### Amendment to the Drawing

A replacement formal drawing is submitted consisting of FIGs 1, 2, 3, 4A, 4B, 4C, 5, 6A, and 6B on 9 sheets.

An amendment to the title is requested, replacing the title as filed in the subject application ("Hand-Held Stun Gun For Incapacitating A Human Target") with "Less Lethal Weapons And Methods For Halting Locomotion".

FIG. 1

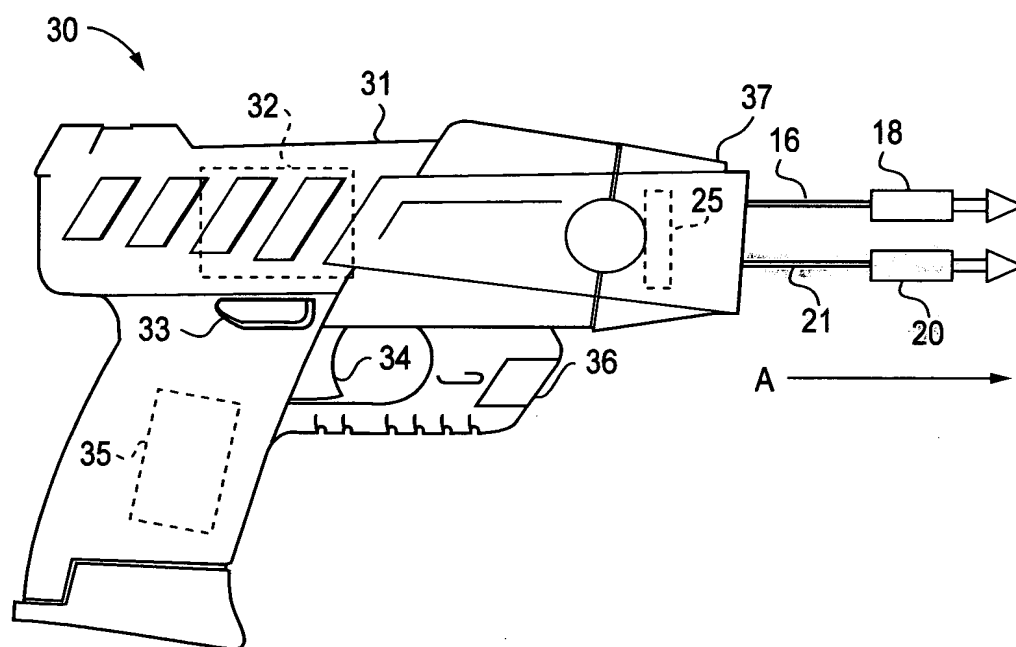
FIG. 1 of the amended drawing is the same as FIG. 1 of the originally filed drawing and shows a second dart 20 and wire 21. Support for a second dart and wire is found, *inter alia*, at originally filed FIG. 2 of the present application and in the originally filed text such as at paragraph [0029] and [0030] of the marked up version of the substitute specification. No new matter is submitted in the amended FIG. 1.

FIG. 2

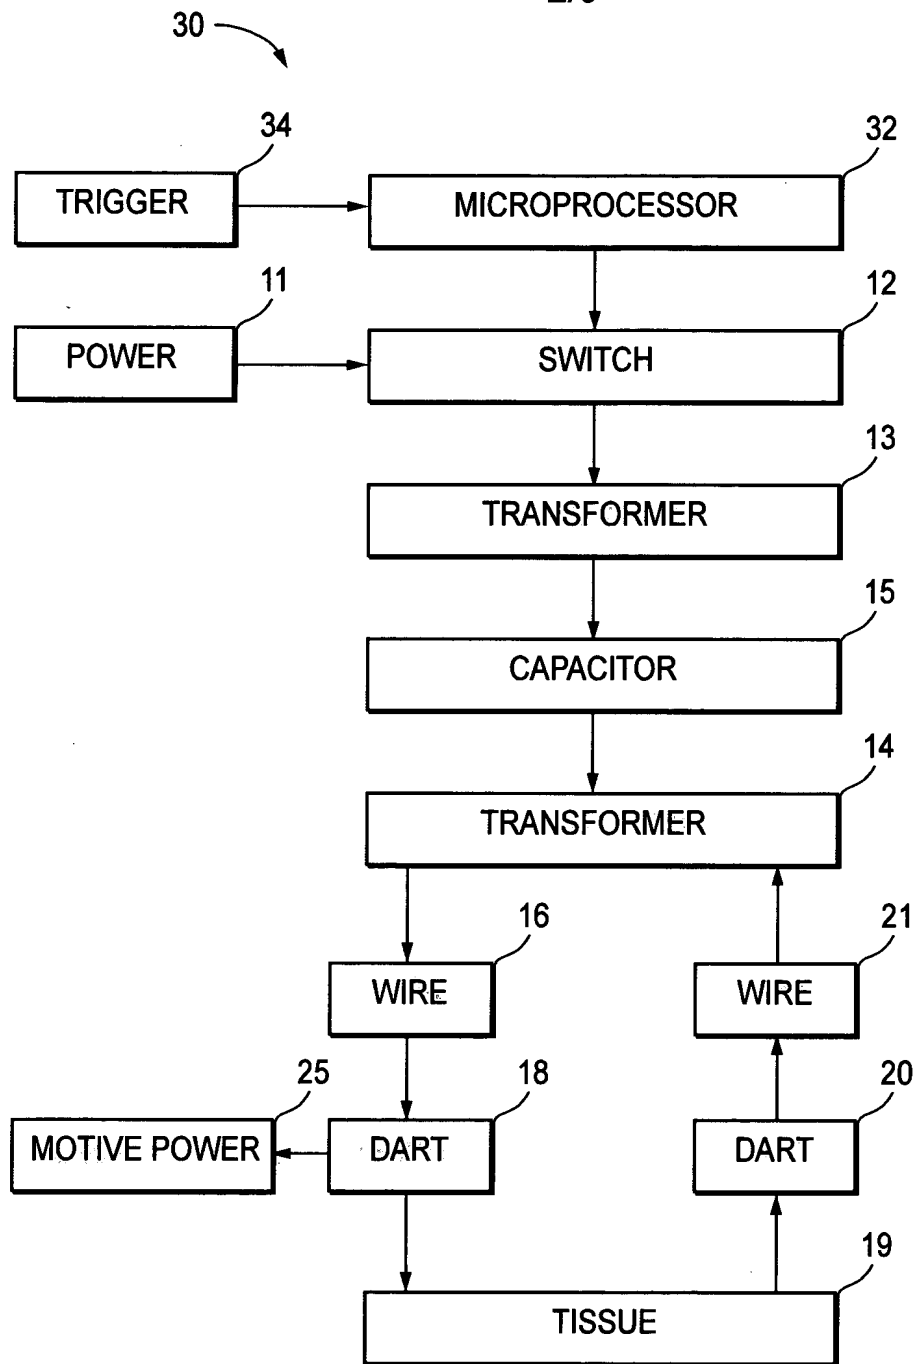
FIG. 2 of the amended drawing is an amended version of originally filed FIG. 2 of the present application. Non-uniform signal flow is corrected.

The relationship between wire 21 and transformer 14 is corrected. Support for FIG. 2 of the amended drawing is found, *inter alia*, at originally filed FIG. 2 of the present application and in the originally filed text such as at paragraphs of the marked up version of the substitute specification [0021] line 5, [0022] lines 4-5, [0023] lines 6-7, [0024] lines 5-6, [0025] lines 3-6, [0026] lines 4-5, and [0027] lines 4-5 each stating “a second conducting unit for transmitting electrical energy from the target to the apparatus” and in the originally filed claims. It is error to show on a block flow diagram the relationship between transformer 14 and wire 21 with reference to a “ground” of the weapon. Such a presentation may be appropriate for an electrical circuit schematic diagram, but is incorrect for a block flow diagram. FIG. 2 of the originally filed drawing and of the amended drawing is a block flow diagram, not an electrical schematic diagram. The “electrical energy” “transmitted” by wire 21 to “the apparatus” must complete a circuit with transformer 14 or the function of transformer 14 to step up the voltage of pulses from capacitor 14 cannot be accomplished. The correction is obvious from the type of diagram and no alternate presentation that is consistent with the text is possible. No new matter is submitted.

FIG. 4A

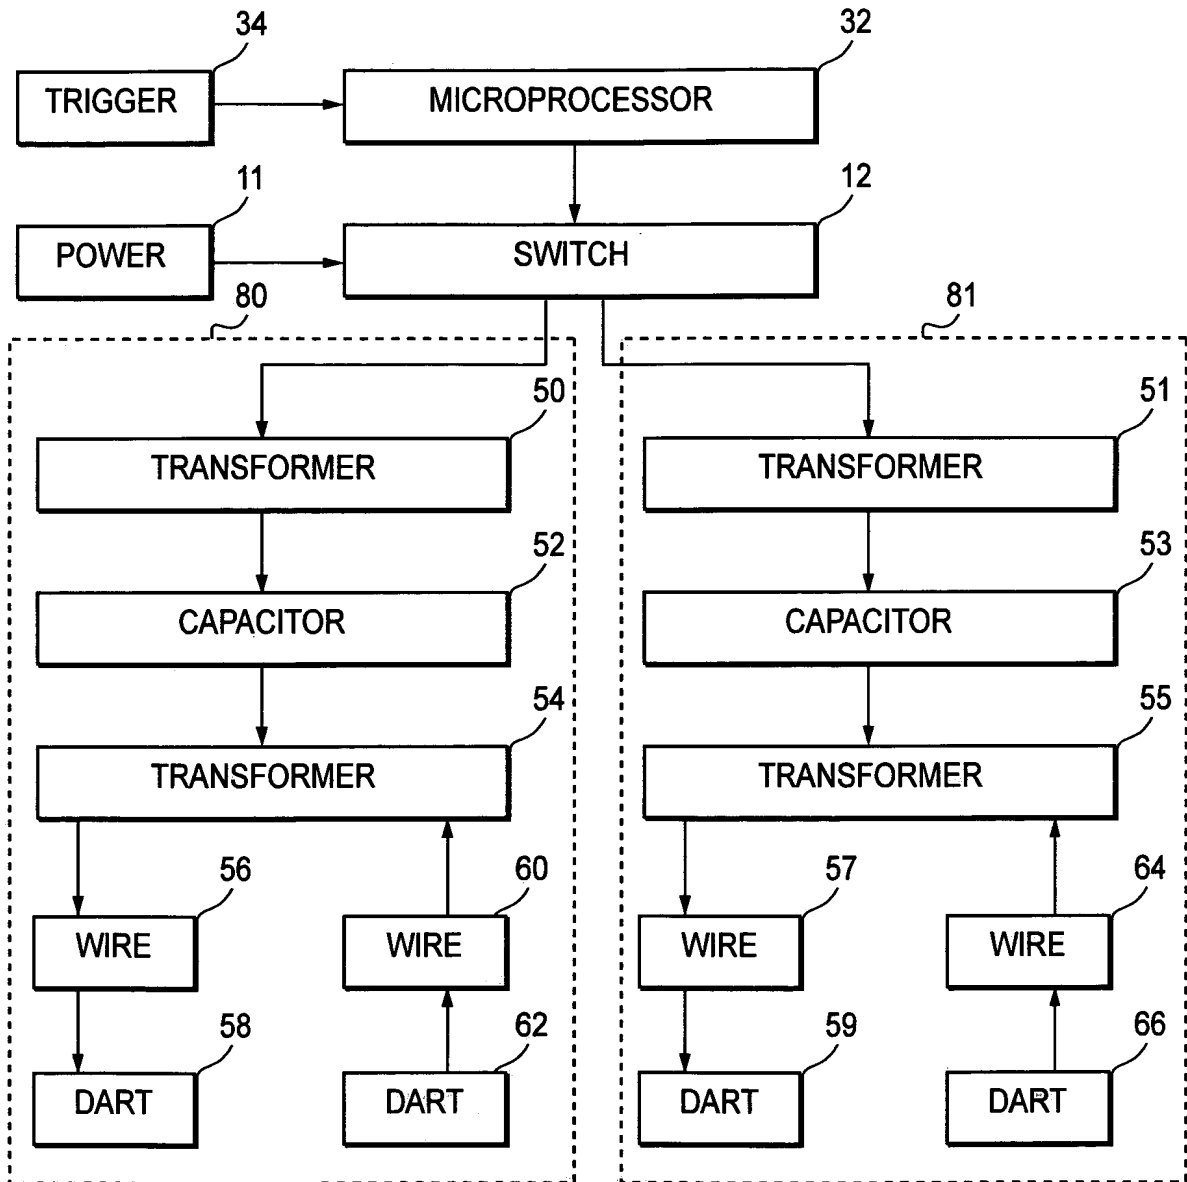
FIGs. 4A, 4B, and 4C replace originally filed FIG. 3 and find support, *inter alia*, for example in originally filed FIG. 3 taken with the text of paragraphs [0041] through [0050] of the marked up version of the substitute specification. The functional blocks and relationships shown in FIGs. 4A, 4B, and 4C are as described in the priority application and the present application as filed. No new matter is submitted.

Paragraph [0042] of the marked up version of the substitute specification finds support, *inter alia*, in deleted paragraph [0041] and refers to FIG. 4A of the amended drawing. No new matter is added.

FIG. 4B

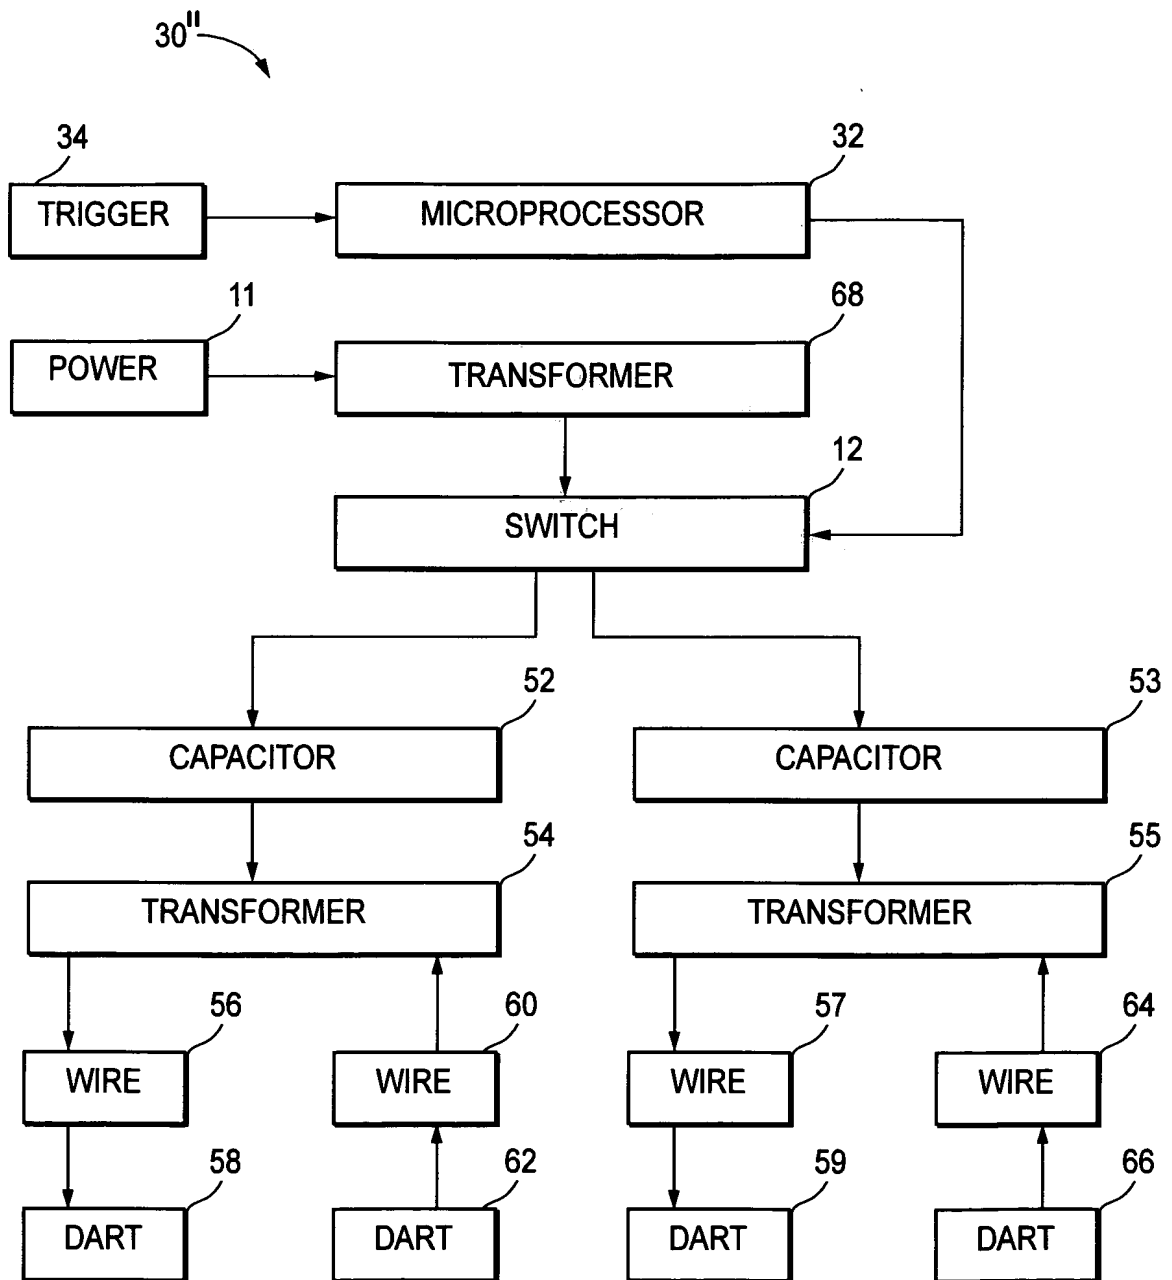
Paragraph [0048] of the marked up version of the substitute specification finds support, *inter alia*, in deleted paragraph [0047] and refers to FIG. 4B of the amended drawing. No new matter is added.

FIG. 4C

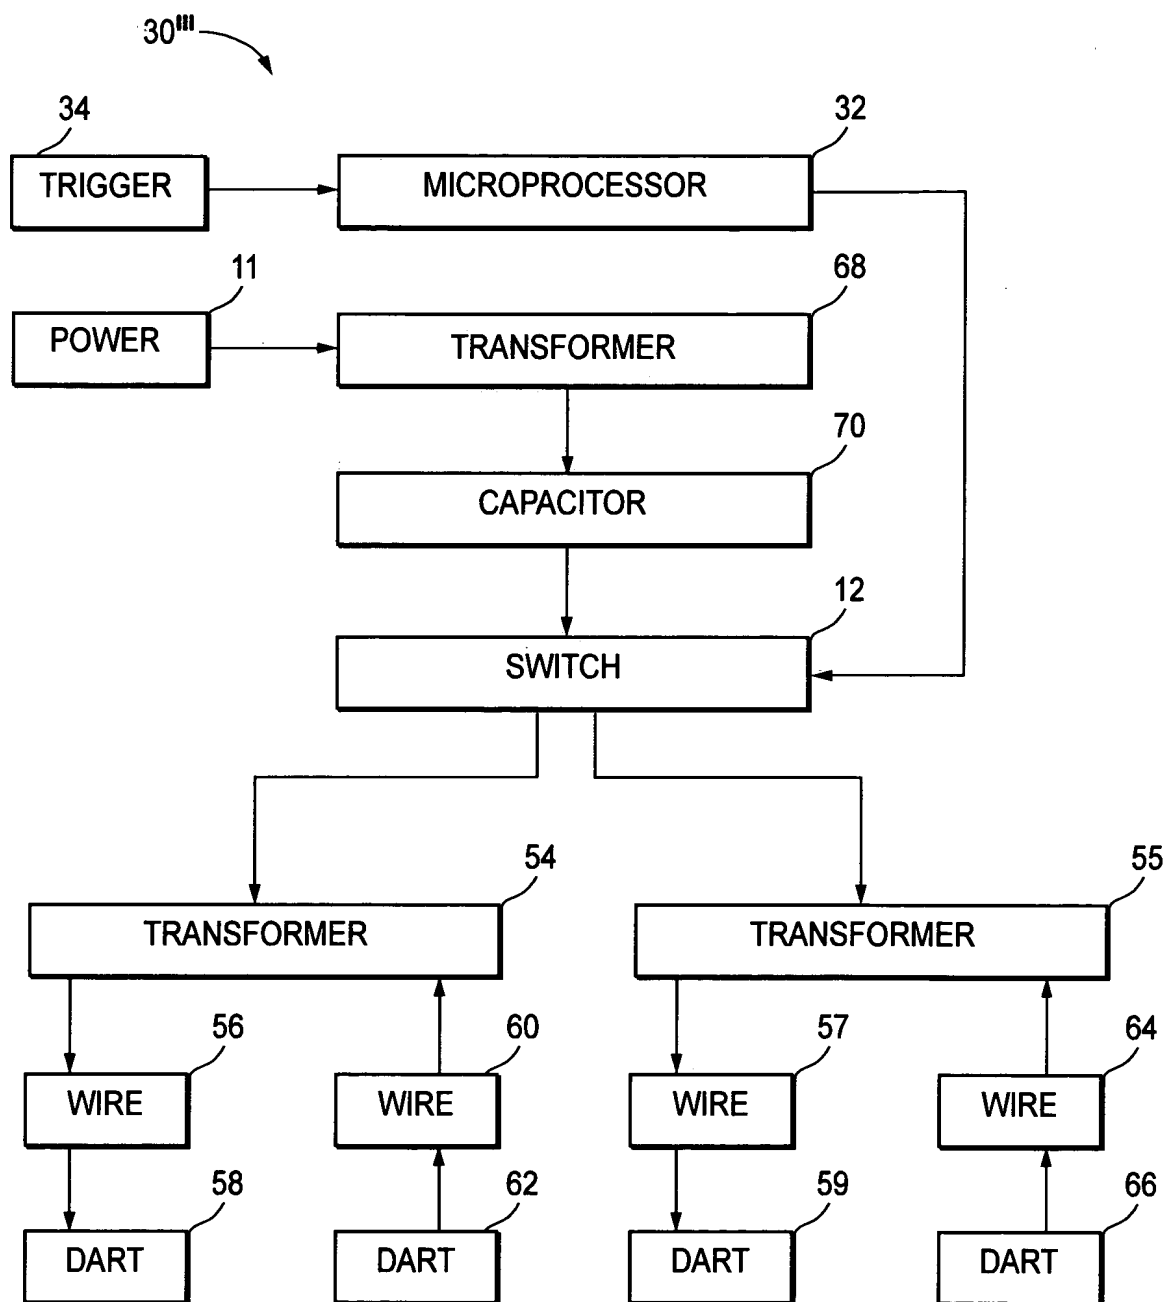
Paragraph [0050] of the marked up version of the substitute specification finds support, *inter alia*, in deleted paragraph [0049] and refers to FIG. 4C of the amended drawing. No new matter is added.

**FIG. 5**  
(PRIOR ART)

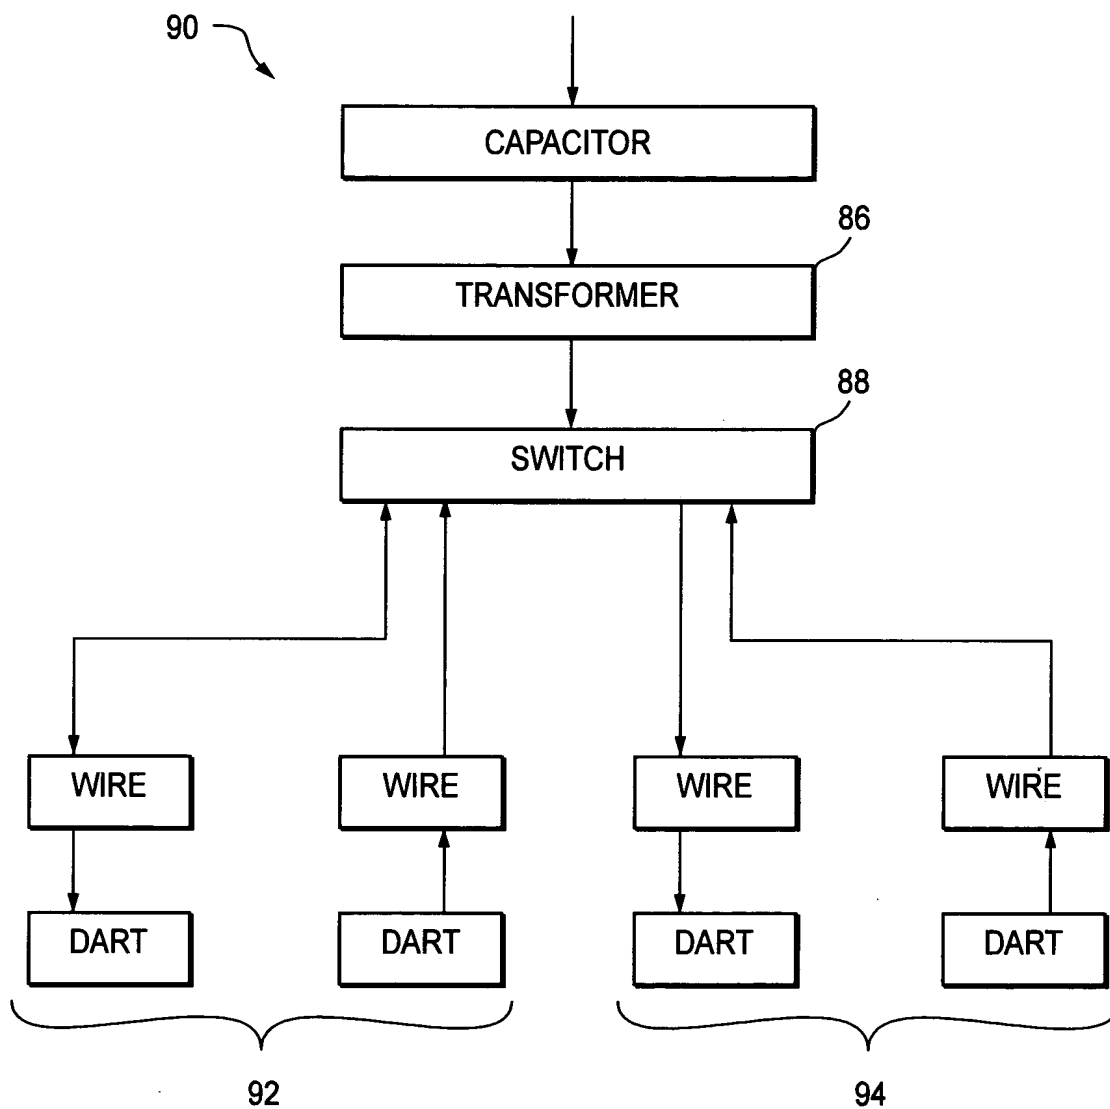
FIG. 5 (Prior Art) aid in understanding paragraph [0051] of the marked up version of the substitute specification. That paragraph admits a drawing. No new matter is submitted.

FIG. 6A

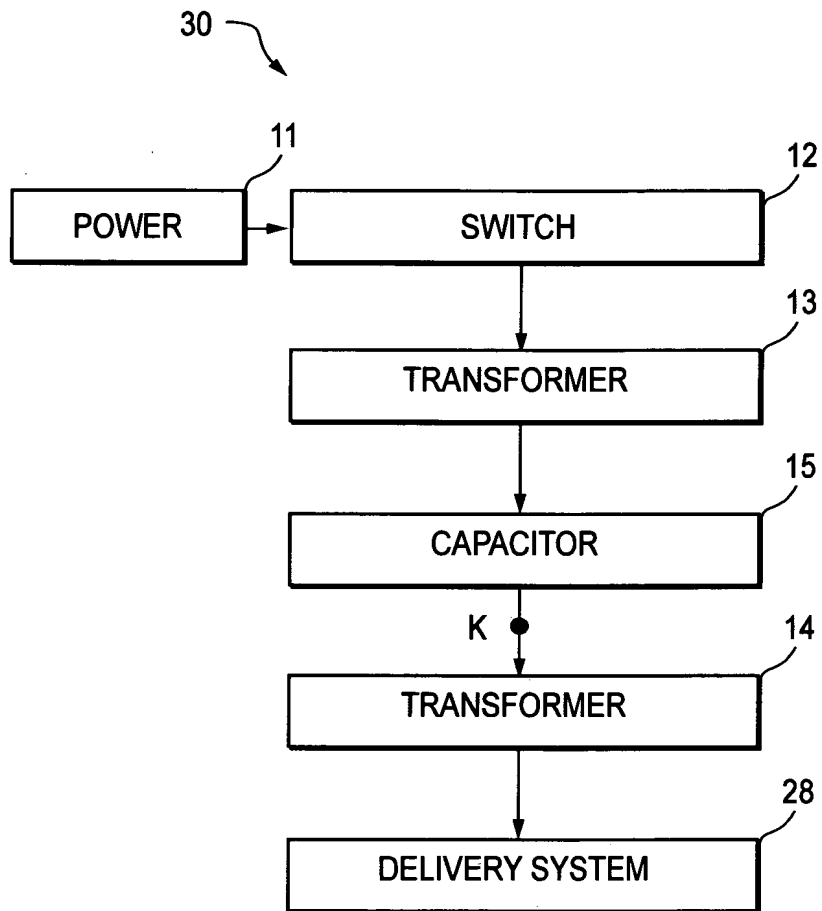
FIGs. 6A and 6B aid in understanding paragraphs [0052] through [0054] of the marked up version of the substitute specification. These paragraphs admit a drawing. No new matter is submitted.
